Notice

Information request

Our reference: EPML00579213

The application reference number is: A-EA-AMD-100600739

Figure 6 - Protected Wildlife Habitat

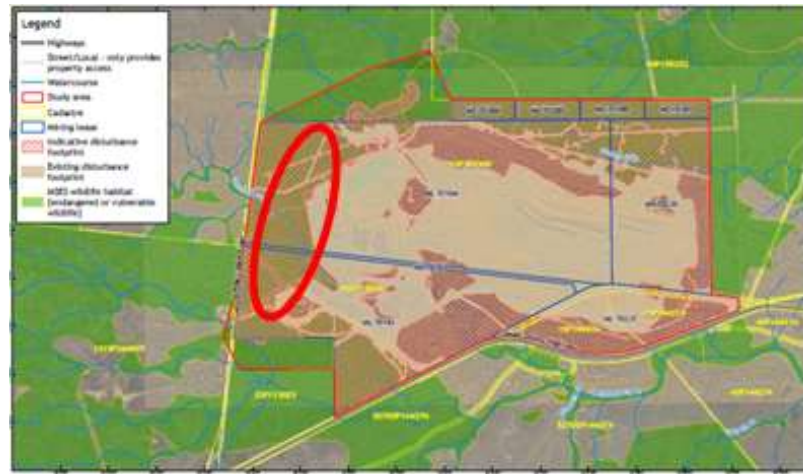
<p>6.</p>	<p>Humbug Gully Creek diversion</p>	<p>Figure 3 – <i>MSES Vegetation</i>, Appendix H, Desktop Assessment for Prescribed Environmental Matters at Coppabella Mine, submitted with the EA amendment application depicts MSES vegetation on ML70161 in the proposed location of the creek diversion and associated water management landforms. Figure 6 – <i>Protected Wildlife Habitat</i> and Figure 9 – <i>Category B Remnant Vegetation within a Prescribed Distance of a Watercourse</i> in the same document also depict MSES wildlife habitat and Category B Remnant Vegetation within a Prescribed Distance of a Watercourse on ML70161 and ML70164 in the proposed location of the creek diversion and associated water management landforms.</p> <p>A description of impacts from the proposed amendment on the environmental values of land in the location of the Humbug Gully Creek diversion was not provided in the amendment application.</p>  <p>Figure 3 – MSES Vegetation</p>	<p>- Provide details in regard to the relative risks and likely magnitude of impacts on environmental values in the location of the Humbug Gully Creek diversion.</p>
